PIC12F609/615/12HV609/615

PIC12F609/615/12HV609/615 Rev. A Silicon/Data Sheet Errata

The PIC12F609/615/12HV609/615 parts you have received conform functionally to the Device Data Sheet (DS41302A), except for the anomalies described below.

8-Lead Plastic Micro Small Outline Package (MS) [MSOP]

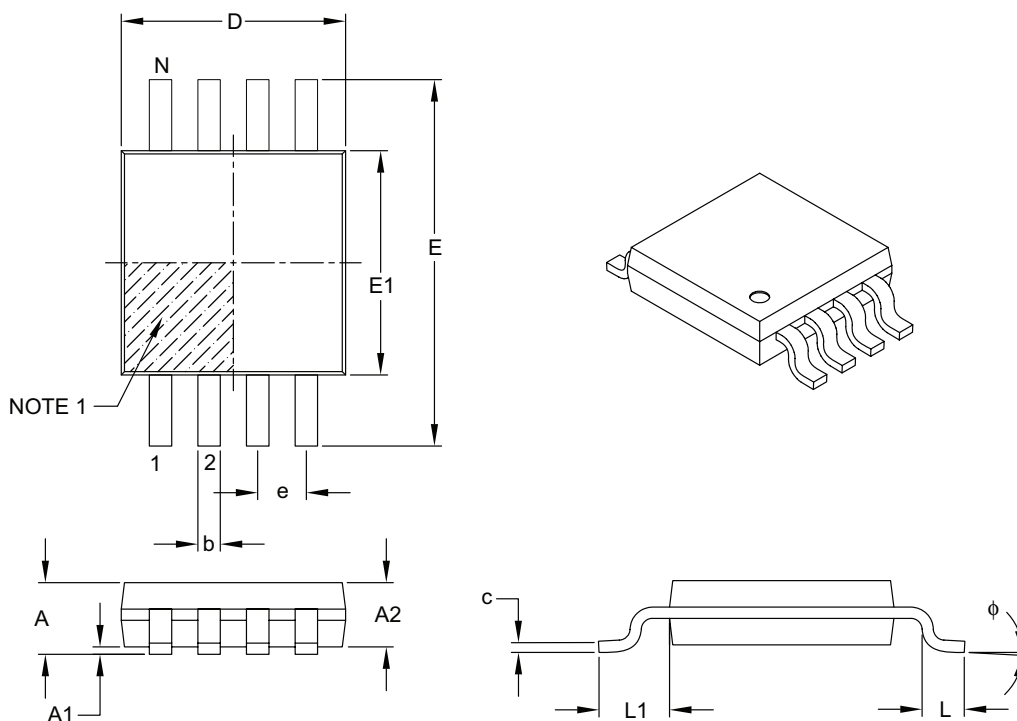
6. Module: 17.0 PACKAGING INFORMATION

Replace TSSOP package with **MSOP** package as shown.
